Proposed Revisions to a Standard Plans Index

Index Number: 350-001 Sheet Number (s): All

Index Title: Concrete Pavement Joints

Summary of the changes:

JOINT SEAL DIMENSIONS

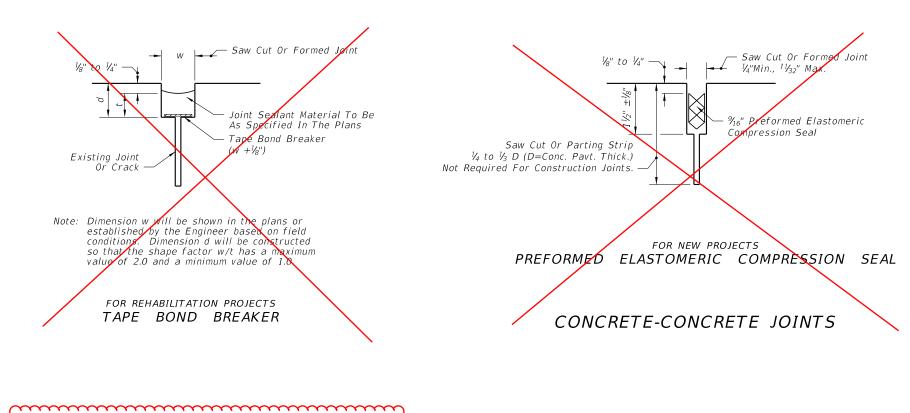
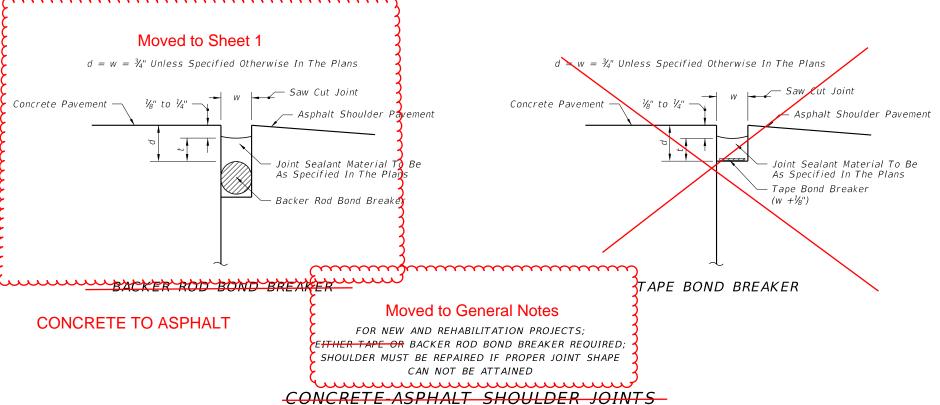
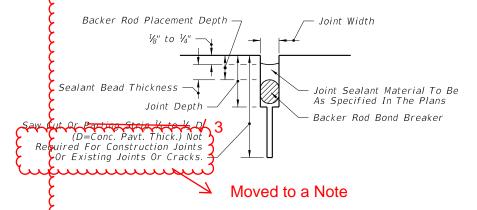
Sheet 2: Moved the Joint Seal Dimensions details to Sheet 1.

Moved to Sheet 1

STEEL HOOK BOLT ASSEMBLY

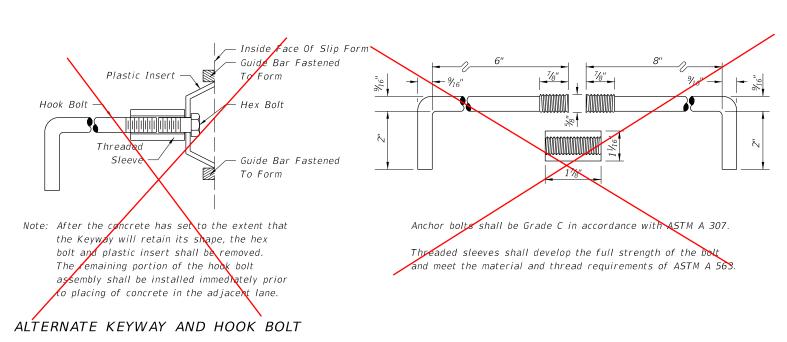
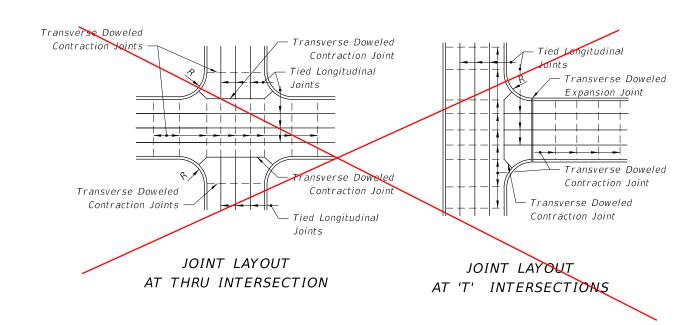
General cleanup/simplification of all sheets. Elimination of outdated or unused details (e.g., steel hook bolt assembly, vibro case method contraction joint detail). Addition of new joint layout details for intersections. Addition of isolation joint details. This update is for clarification and addition of new helpful details. No new or addi

CONTRACTION ASSEMBLY

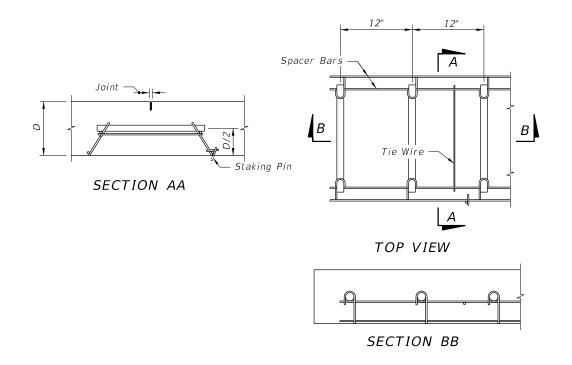
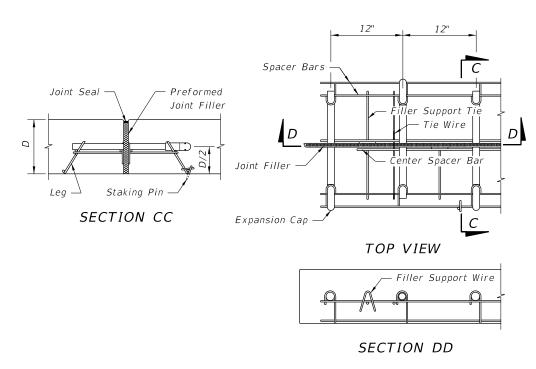
Moved to Sheet 3

Moved to Sheet 4 FY 2022-23

LARGE RIGHT TURN, STANDARD INTERSECTION, AND SKEWED INTERSECTION DETAILS

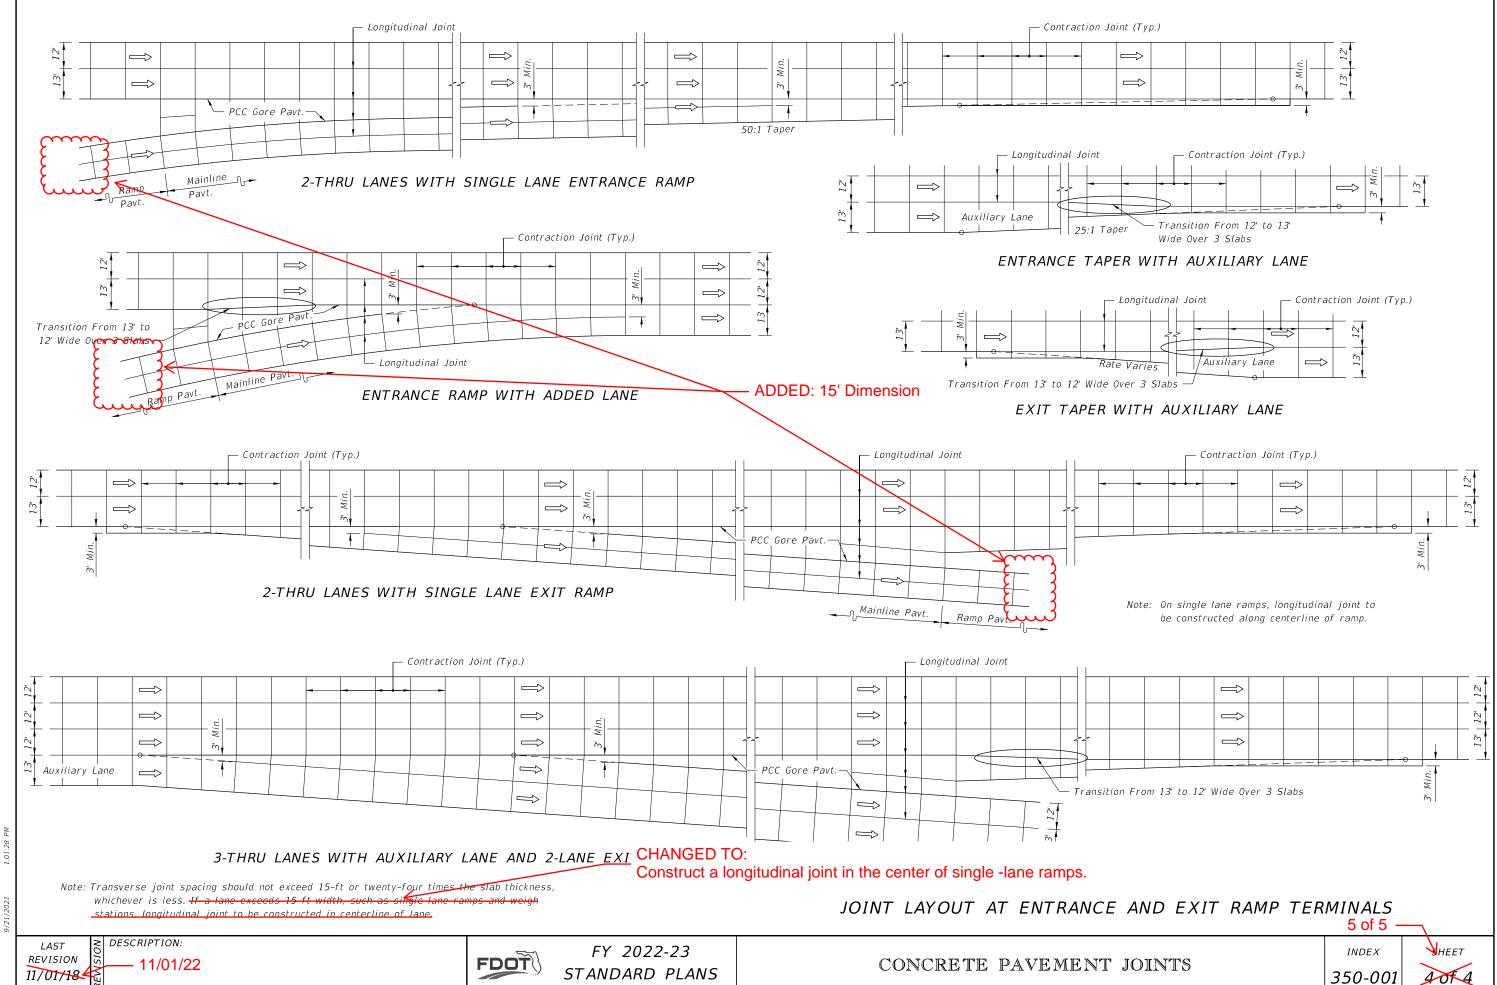
New Sheet 3: Large Right Turn, Standard Intersection, and Skewed Intersection Details.

ISOLATION JOINT DETAILS

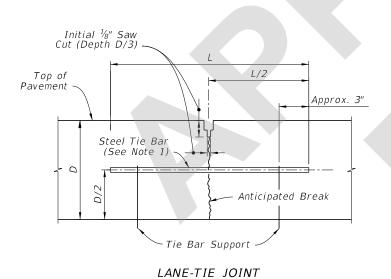
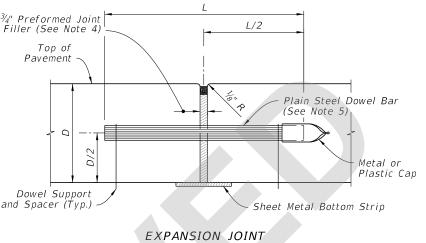
New Sheet 4: Isolation Joint Details.
